From: Kresl, Zachary (FHWA) <zach.kresl@dot.gov>
Sent: Wednesday, March 3, 2021 1:02 PM
To: Smith, Jacob; Maiefski, Melissa; Petracek, Sue; pjinfne@dot.gov
Cc: Barber, Jon; Pitts, Luke
Subject: RE: For Your Review: Plan Revision R-1 Reevaluation, 21209, Murray - Plattsmouth

Subj: Project No. NH-75-2(128), C.N. 21209, Murray – Plattsmouth
Plan Revision R-1

Revised Sheets:	A2
Deleted Sheet:	B6
Added Sheets:	B6A, N13, N14

THIS SET OF PLANS IS
DRAFT PLAN REVISION 1

LIGHTING

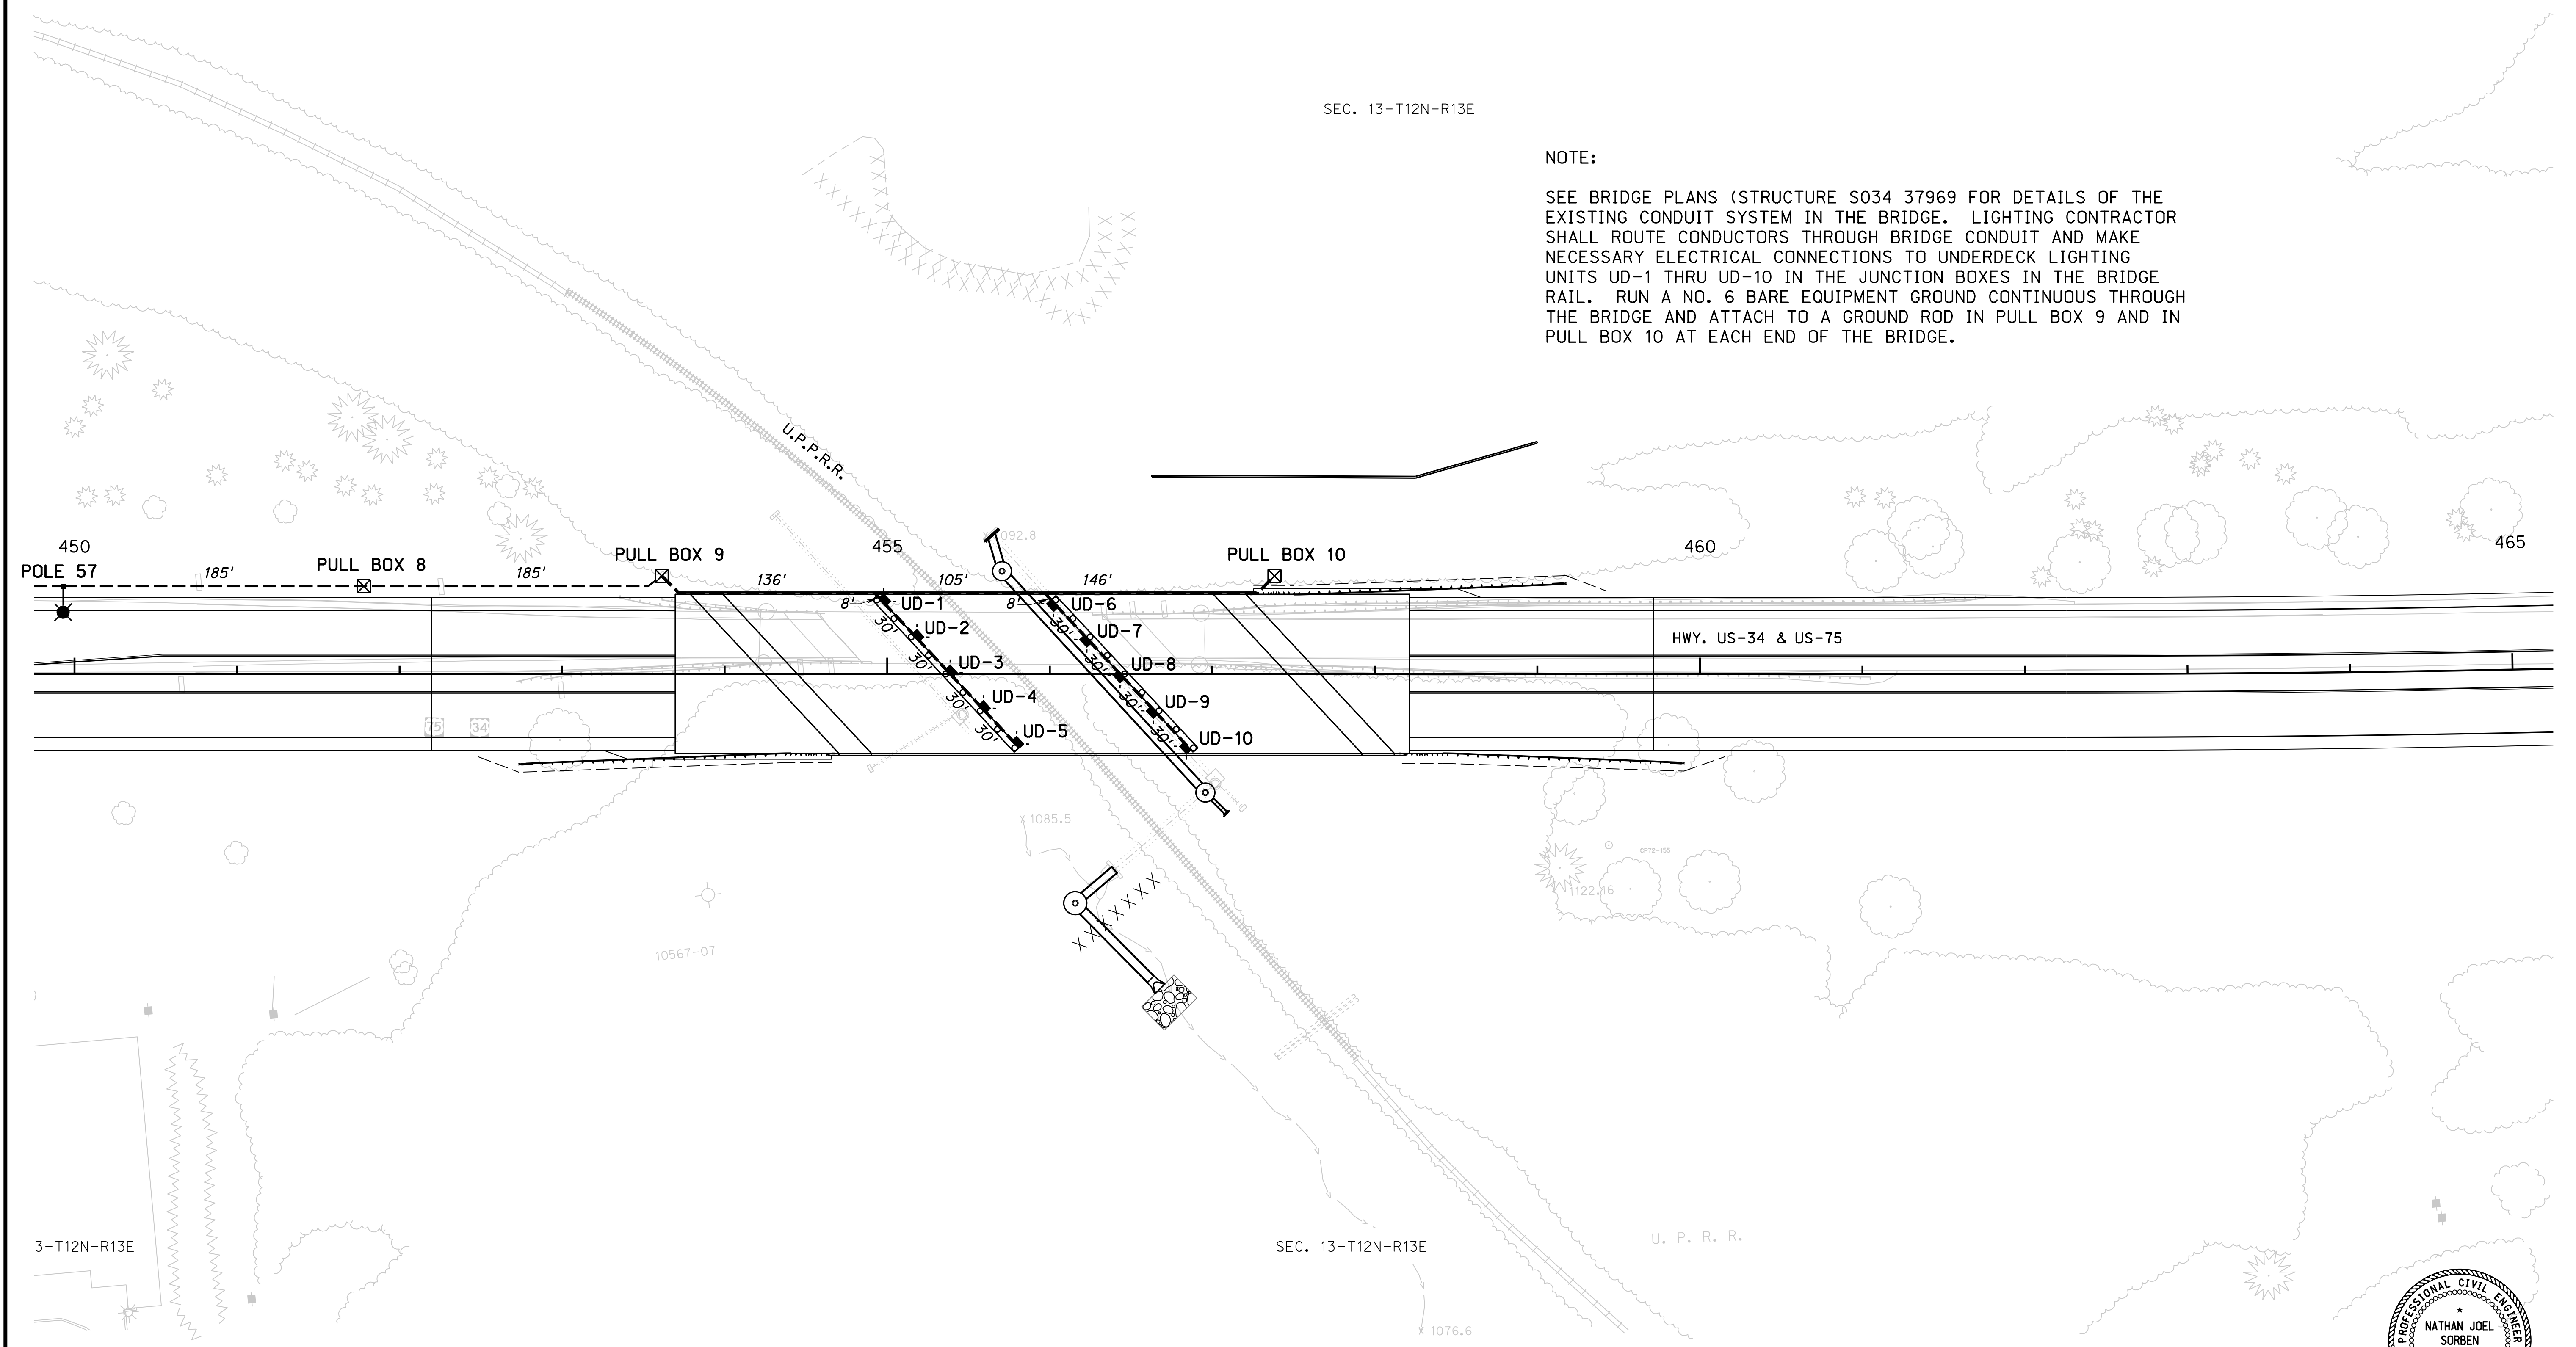
- Sheets N13 and N14 were added to show lighting details for the underdeck bridge lighting for structure #S034 37969 over the UPRR.
